CONSTRUCTION CHANGE ORDER 04

Block 75 Parking Ramp Maintenance Project #2689

To: SECO Construction, Inc. AEI#: 2021-504  
Contractor  
P.O. Box 2921 Contract: Prime Construction  
Rapid City, SD 57709 Date: August 16, 2023

Image 1

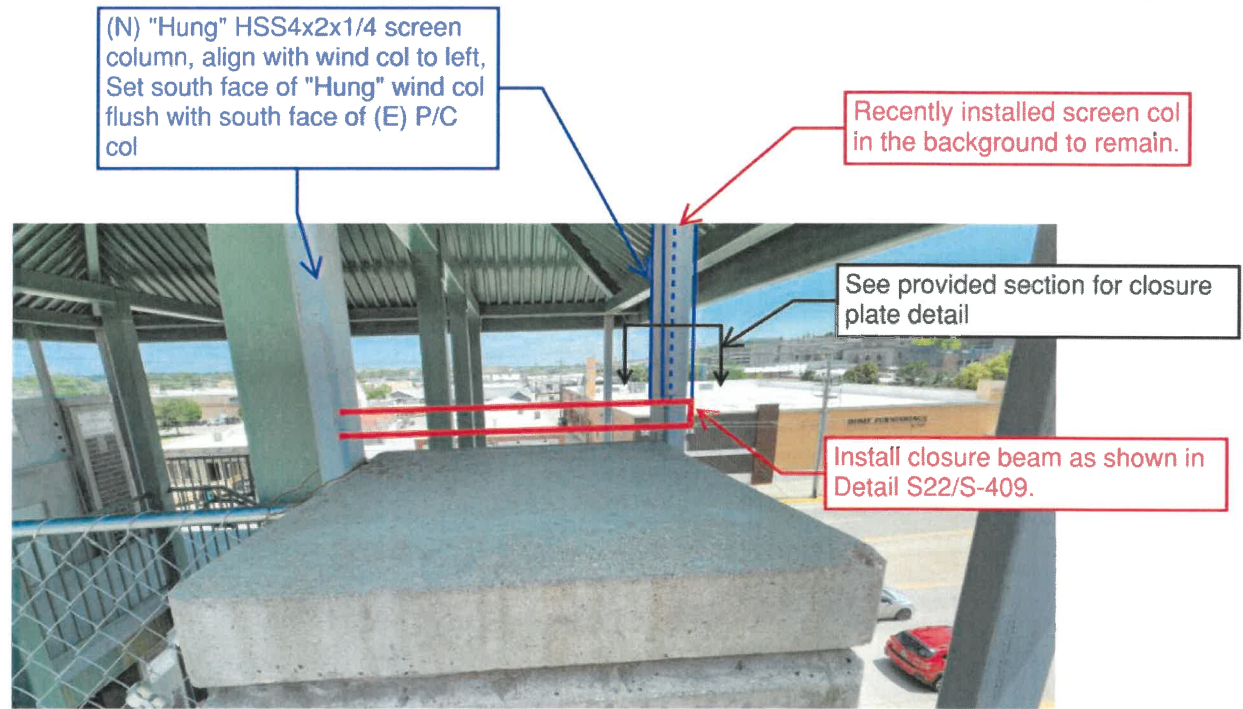
On the 3<sup>rd</sup> floor at the SE Stair southwest corner, the storefront is shown to jog laterally over the existing precast column. However, there is no steel present to frame out the section of storefront directly over the precast column. An additional "hung" HSS4x2x1/4 screen column will be required to closeout the storefront above the precast column. Moreover, a 1/4" closure plate will be required between the "hung" screen column and one already installed. Please refer to the picture and the closure detail below for additional information.

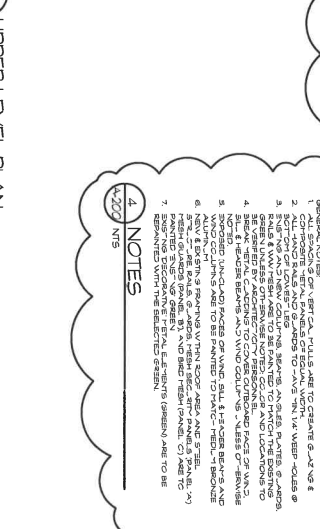
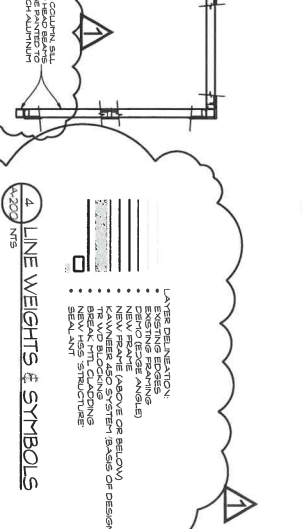
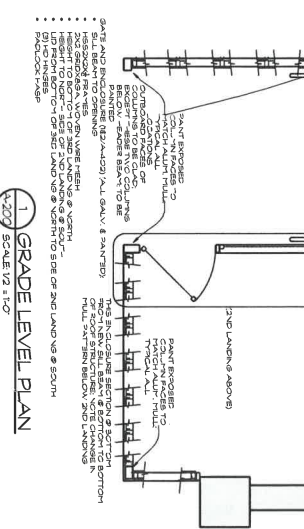
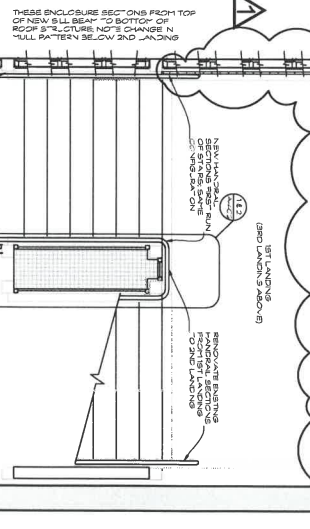
Per RFI #009, there are two glass panes on the east stair (and there will be two panes on the west stair) which are not shown in the construction documents to get guard mesh panels. This RFP is requesting a lump sum cost for the installation of (4) additional glass guard mesh panels at these locations. These new guard mesh panels are to be considered in a similar manner to those already installed/shown in the CD's. See the attached sheets for additional information.

**SHEET NUMBER:** S-106

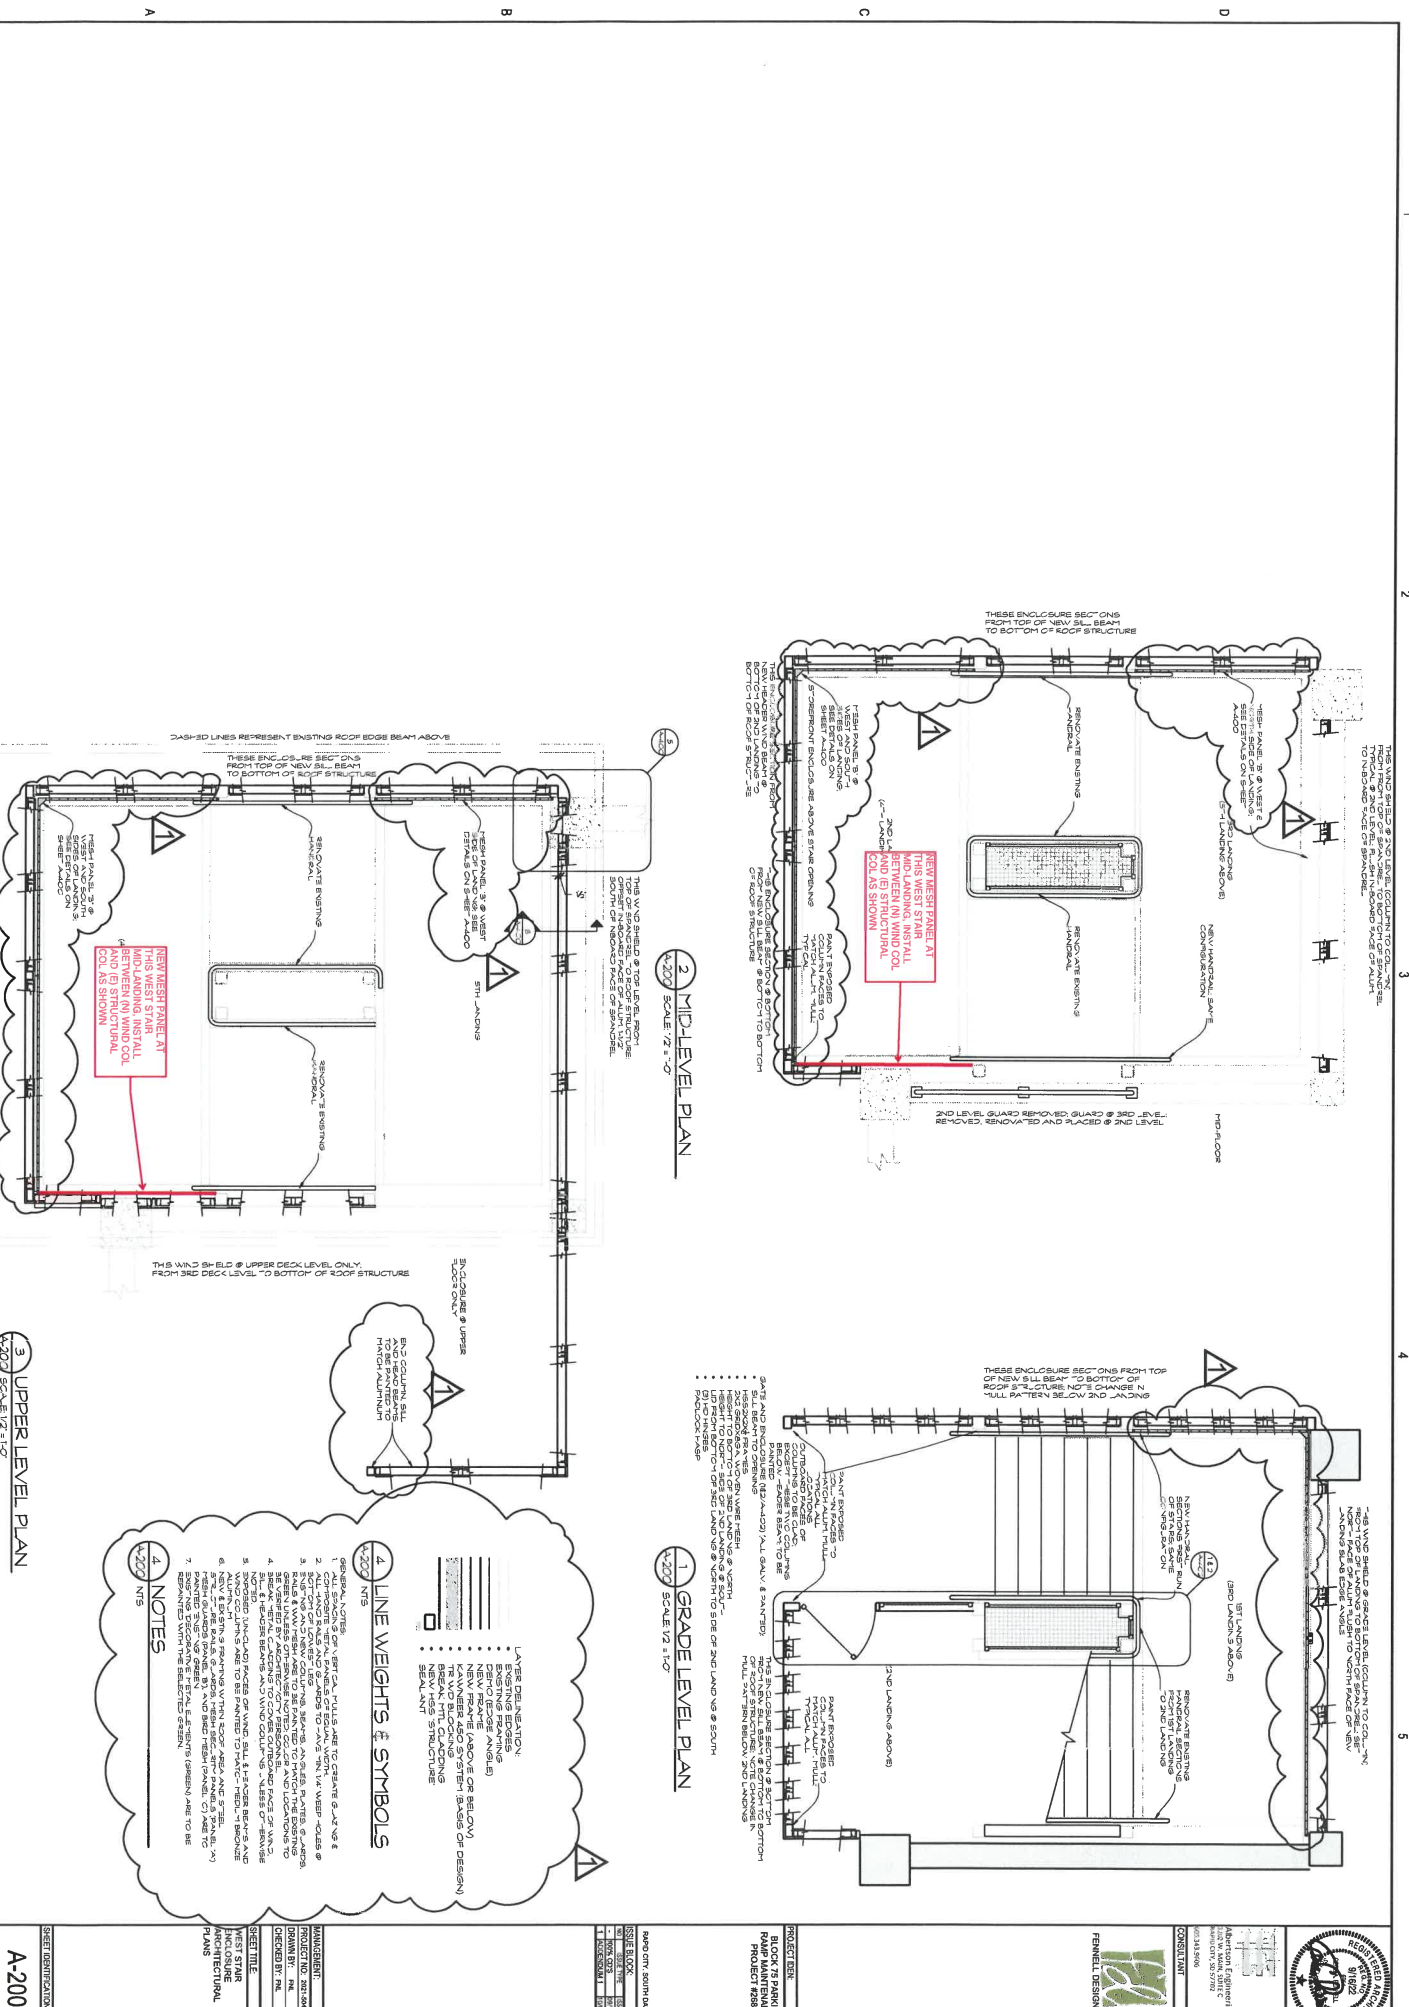
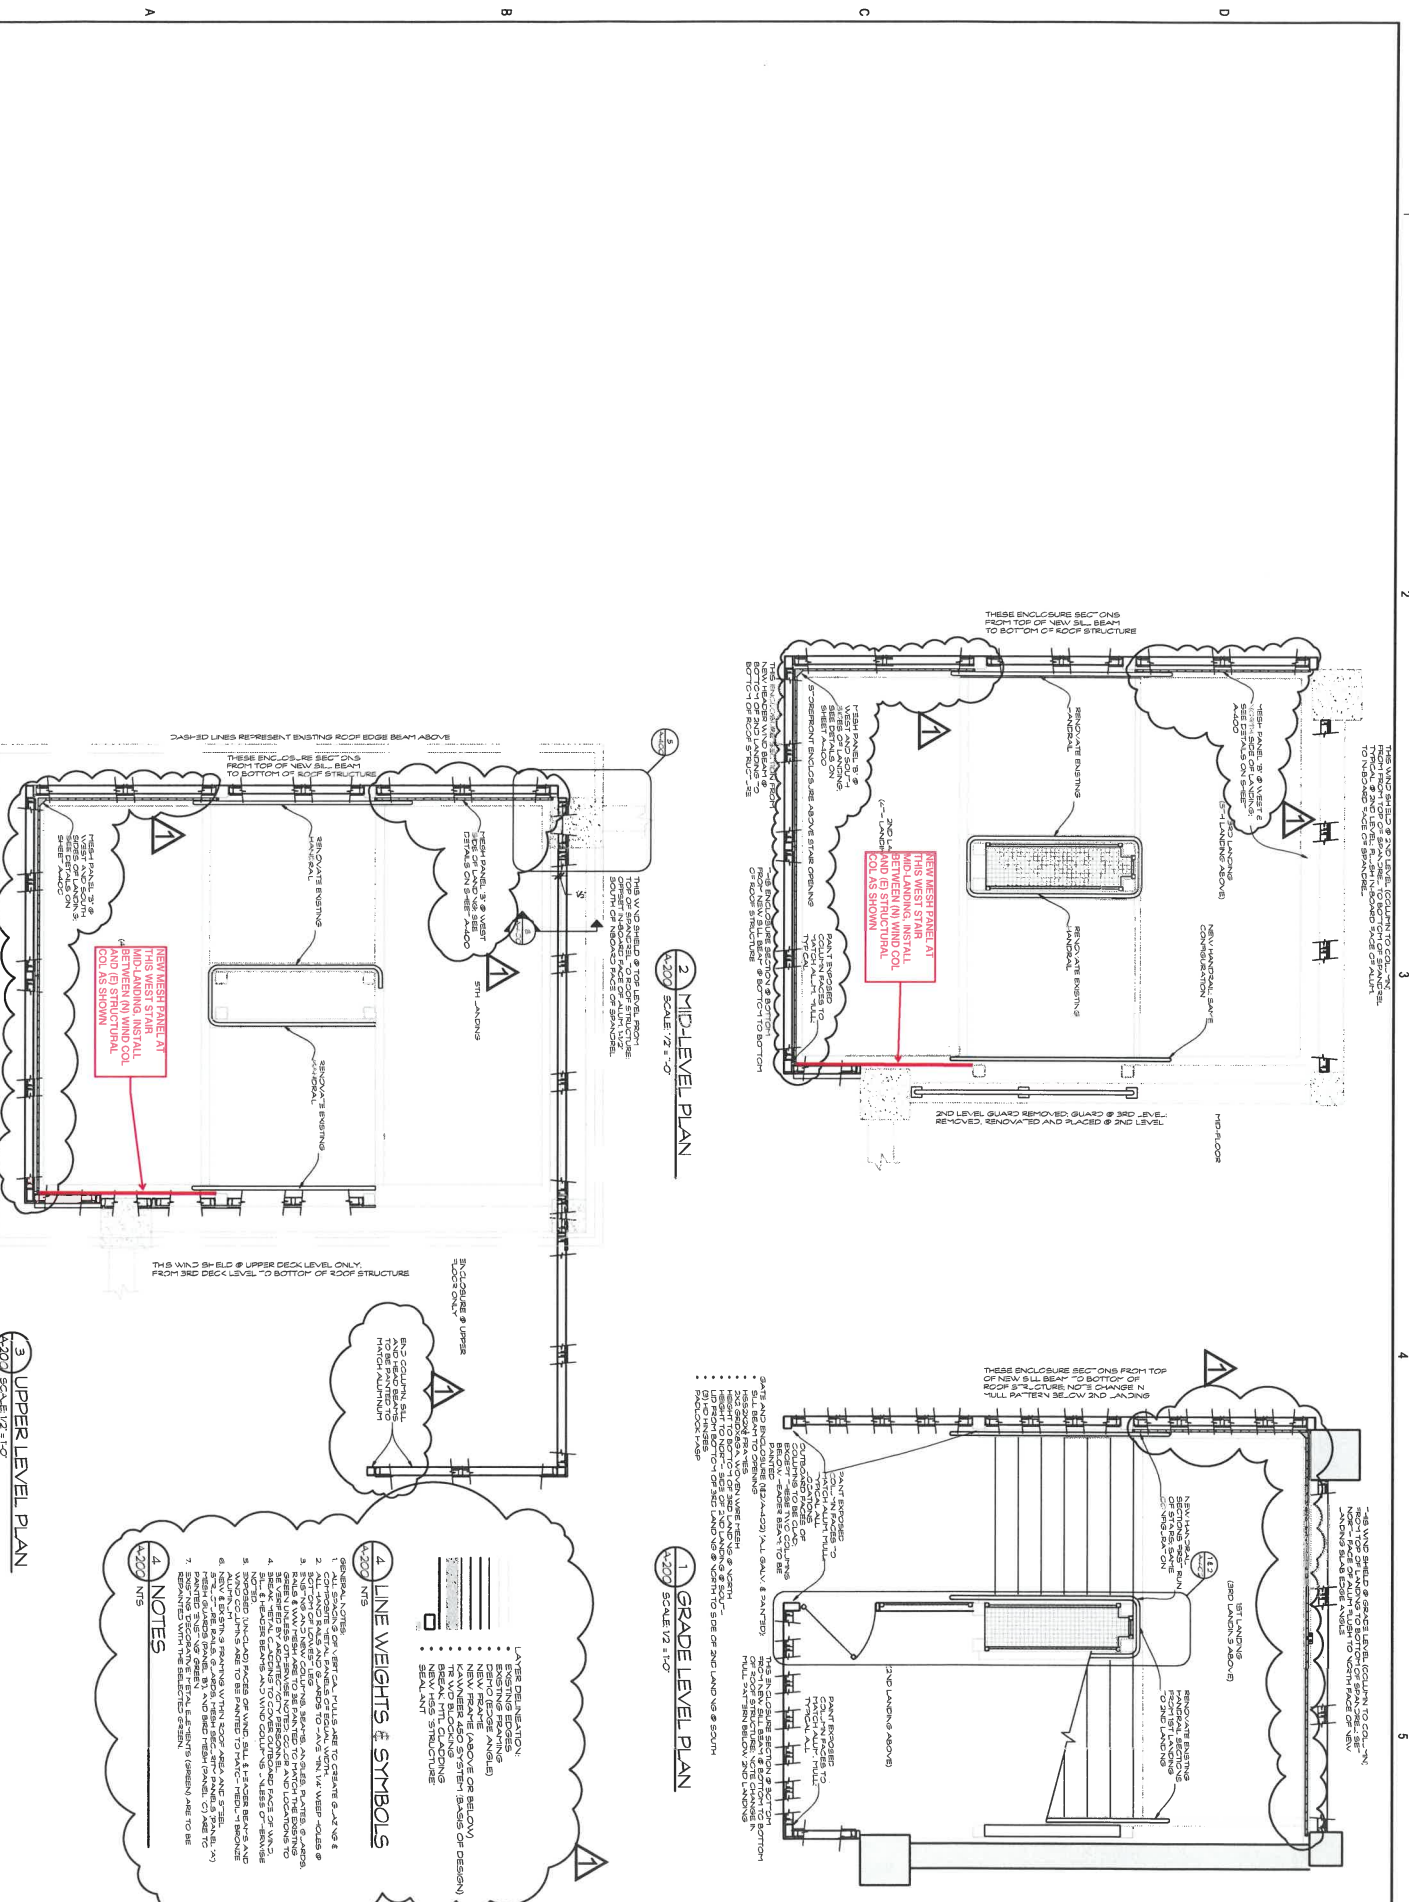
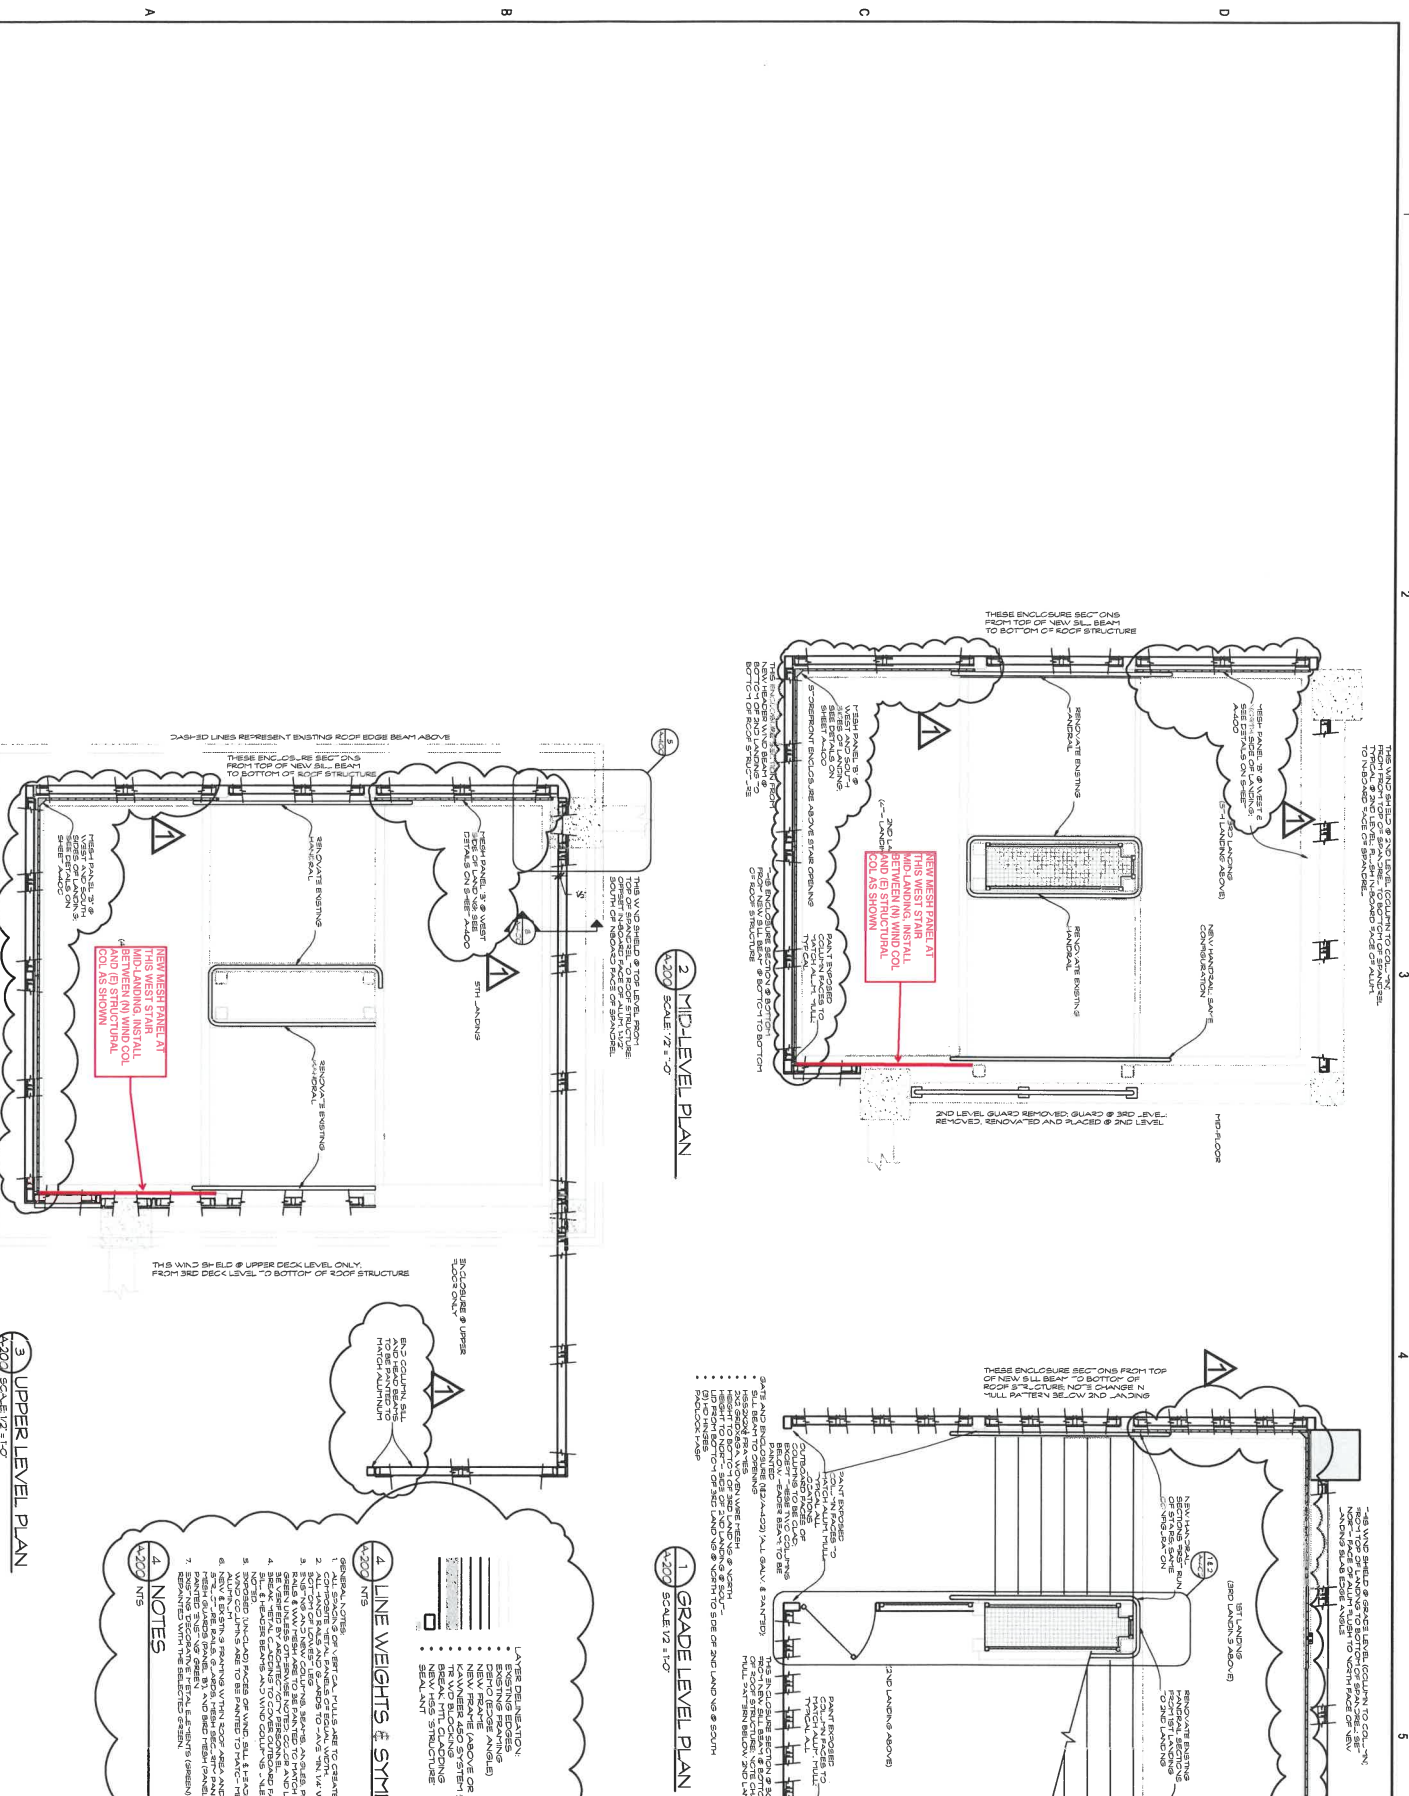
Due to existing stripping patterns on the 3<sup>rd</sup> floor adjacent to both stairways, the plan dimensions for the wind screens have to change. Attached at the end of this RFP are annotated copies of S-105 and S-106 to address the dimensions for the proposed wind screens. Please also note that at each stair only (2) bollards will be required, not (3) as originally shown in the CD's. The pricing is to include revisions associated with the structural steel modifications as well as the storefront glazing.
